Project	<b>IEEE 802.16 Broadband Wireless Access Working Group</b> < <a href="http://ieee802.org/16">http://ieee802.org/16</a> >
Title	<b>CR on SDD Section 17: Facilitating Entry of New Femto BS into the Network</b>
Date Submitted	<b>2009-02-24</b>
Source(s)	Karthik Sundaresan, Sampath Rangarajan, <a href="mailto:karthiks@nec-labs.com">karthiks@nec-labs.com</a> Linghang Fan, Nader Zein, Tetsu Ikeda, Andreas Maeder, Amir Khojastepour, Mohammad Madihian NEC
Re:	Change request to Project 802.16m System Description Document (SDD) (IEEE 802.16m-08/003r7)
Abstract	This contribution provides text addition to SDD to facilitate entry of a new femto BS into the network.
Purpose	For discussion and approval by IEEE 802.16m TG
Notice	<i>This document does not represent the agreed views of the IEEE 802.16 Working Group or any of its subgroups. It represents only the views of the participants listed in the "Source(s)" field above. It is offered as a basis for discussion. It is not binding on the contributor(s), who reserve(s) the right to add, amend or withdraw material contained herein.</i>

# Facilitating Entry of New Femto BS into the Network

Figure 1. Femto/Macro Network Illustration.

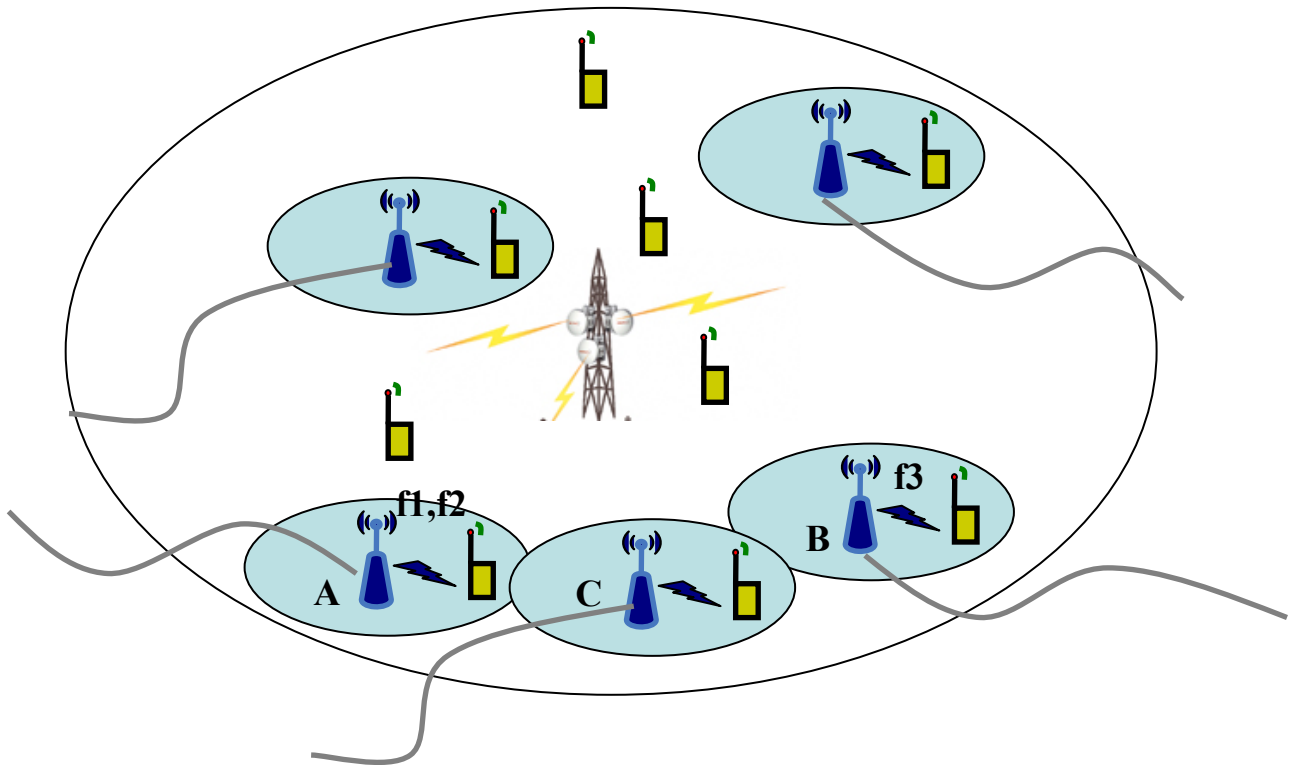
It is often possible that the macro BS may not be able to coordinate resource allocation among femto cells and the femto BS have to autonomously determine their resource region. This is especially likely in moderate to high load scenarios. The SDD currently specifies that a femto BS will measure power on all carriers from neighboring femto/micro/macro BS and accordingly choose a carrier perceived to have low interference. However, in moderate to high load scenarios, where the available resources are being utilized by existing femto BS, a new femto BS entering the network is likely to see high interference on all available resources from its neighboring femto/micro cells. This could potentially result in starvation of the new femto cell being deployed in the network. For eg., consider the scenario shown in Figure 1, where there are three carriers/channels available in the network:  $f_1, f_2$  and  $f_3$ . Femto BS A and B have already been deployed and split the resources as say  $f_1, f_2$  for A and  $f_3$  for B. Now when the femto BS C gets deployed, it finds strong interference on all the available carriers from its neighbors. This leads to starvation of the newly deployed femto BS C and its associated clients.

This problem is exacerbated in cases, where there is no coordination of resources (to be used by the femto BS) by the macro BS and the femto BS have to autonomously determine their resource region of operation.

To address this starvation problem, it is essential for the femto BS to have the notion of “resource readjustment”. This essentially means that mechanisms for (centralized/distributed) resource allocation should be executed by the femto/macro BS either periodically or based on triggers (eg. entry of new femto BS), which would allow for resources to be shared fairly taking into account the change in network and load dynamics. In the above example, a periodic resource allocation mechanism would trigger the three femto BS to enter into a resource re-allocation phase, whereby the three frequencies would get shared as  $f_1$  for A,  $f_2$  for C and  $f_3$  for B respectively.

It is possible that when a new femto BS is initially deployed, all channels (carriers) could be occupied by neighboring femto/micro BS. In such scenarios, the new femto BS will see high interference level on all channels, resulting in its consequent starvation. To avoid such scenarios, which are common in moderate-high load conditions, mechanisms (centralized/distributed) for resource allocation at the femto/micro BS should be enabled either periodically or based on network triggers.
